Noyac Bay

SUITE 407
ORIGINAL LAYOUT
INVENTORY SUITE

*** SUITE 407 * (INVENTORY SUITE)**
NEW PLAN
-REMOVED DEN
-REVISED KITCHEN
*REVISED LAUNDRY DOOR SWING &
ENSUITE WALL AS PER THIS BROCHURE

CLIENT: ROYAL PINE HOMES	NOVAC BAY (2G)	ROOM: KITCHEN FLOOR PLAN	DRAWN BY: SK
SITE: HAMPTON PLACE	DOOR STYLE: —	DOOR HANDLE: —	SCALE: 1/2" = 1' - 0"
PHONE: —	FINISH: —	DRW HANDLE: —	DATE: MARCH 8, 2018
EMAIL: —	SPECIES: —	TOP: —	PAGE: —

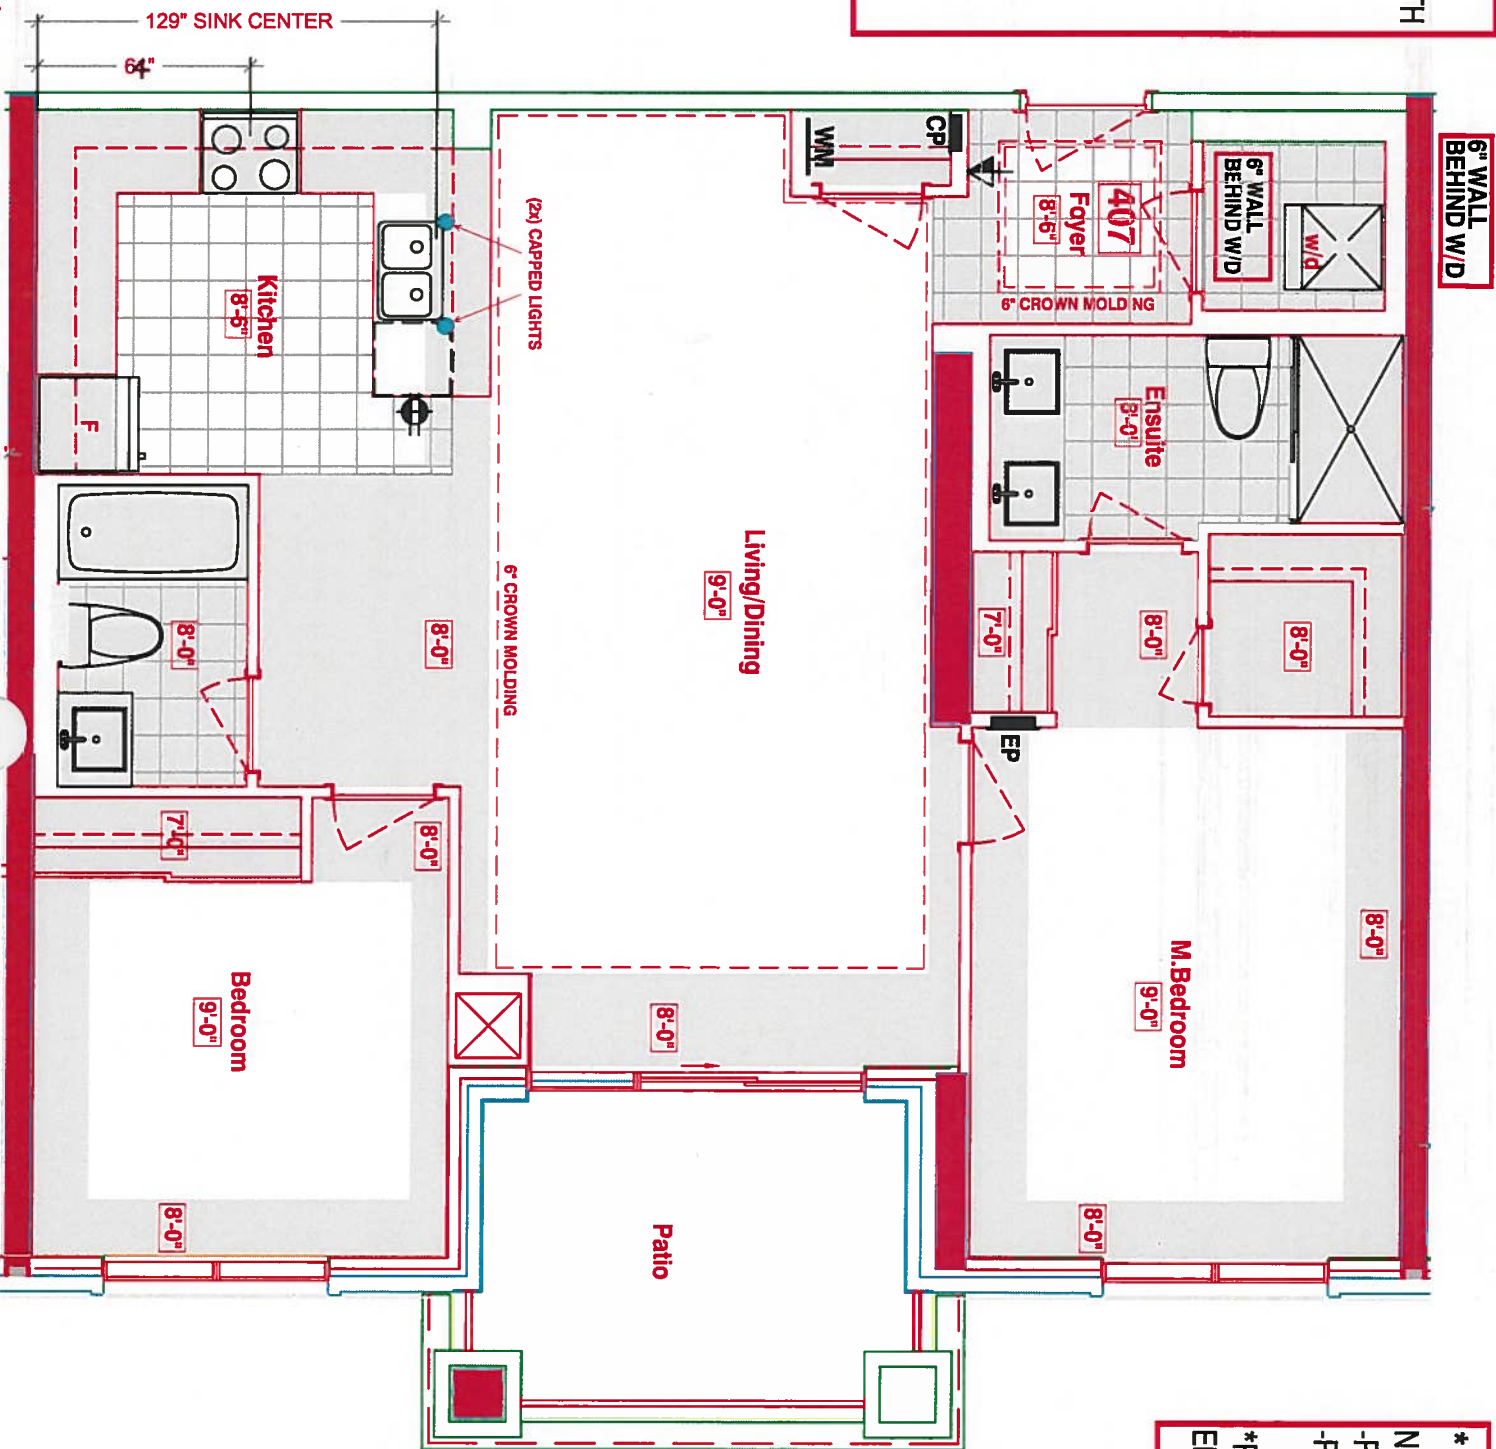
*** KITCHEN ***
CHOICE OF STD. KITCHEN LAYOUT WITH
STD. APPLIANCE PACKAGE
OR
CAN UPGRADE AT DECOR CENTER
- (x2) CAPPED PENDANT
- (x1) *PLUG IN PENINSULA*
- (x) PUCK LIGHTS
*SEE ATTACHED UPG.
#1- KITCHEN LAYOUT WITH 1ST UPG.
APPLIANCE PACKAGE
